DESIGN RF	DRAWN BY RF	DART AEROSPACE LTD HAWKESBURY, ONTARIO, CANADA	
CHECKED 	APPROVED 	DRAWING NO. DSI 9300	REV. B SHEET 1 OF 6
DATE 05.08.12		TITLE SIMPLEX TANK STEP	SCALE NTS
A	05.05.05	NEW ISSUE	
B	05.08.12	ADD STRUTS IF TANK REMOVED

DART SERVICE INSTRUCTION

TO AMEND INSTALLATION INSTRUCTIONS IIN-D205-633 REV. A

THE PURPOSE OF THIS SERVICE INSTRUCTION IS TO ADD THE D205-633-021/-022/-023/-024/-025/-026 STEPS TO ADDRESS COMPATABILITY WITH THE SIMPLEX MODEL 304 FIRE ATTACK TANK. D205-633-021/-022 ARE IDENTICAL TO D205-633-011, EXCEPT AS SHOWN HERE. D205-633-023/-024 ARE IDENTICAL TO D205-633-013, EXCEPT AS SHOWN HERE. D205-633-025/-026 ARE IDENTICAL TO D205-633-015, EXCEPT AS SHOWN HERE.

DETAIL S
NOT TO SCALE

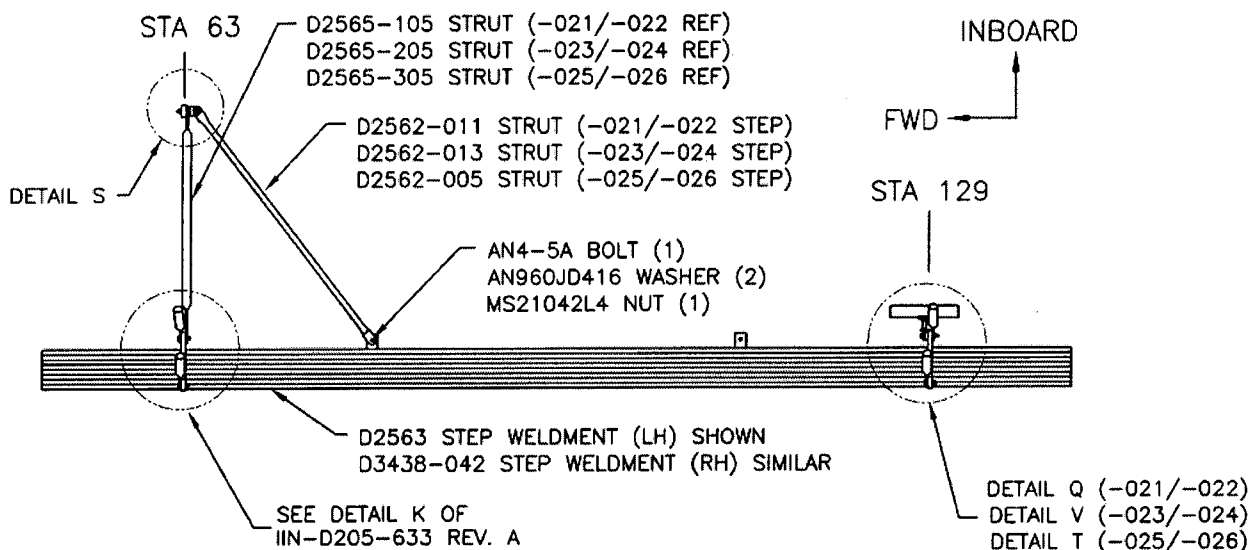
INSTALL D205-633-021/-022 AS PER THE D205-633-011 STEP OF INSTALLATION INSTRUCTIONS IIN-D205-633 REV.A, EXCEPT REPLACE D2565-111 STRUT WITH THE D3437-041 AFT STRUT ASS'Y, REMOVE D2562-001 STRUT, INSTALL D2562-011 STRUT AS SHOWN.

INSTALL D205-633-023/-024 AS PER THE D205-633-013 STEP OF INSTALLATION INSTRUCTIONS IIN-D205-633 REV.A, EXCEPT REPLACE D2565-211 STRUT WITH THE D3437-043 AFT STRUT ASS'Y, REMOVE D2562-003 STRUT, INSTALL D2562-013 STRUT AS SHOWN.

INSTALL D205-633-025/-026 AS PER THE D205-633-015 STEP OF INSTALLATION INSTRUCTIONS IIN-D205-633 REV.A, EXCEPT REPLACE D3165-1 SUPPORT ARM WITH THE D3437-045 AFT STRUT ASS'Y AS SHOWN.
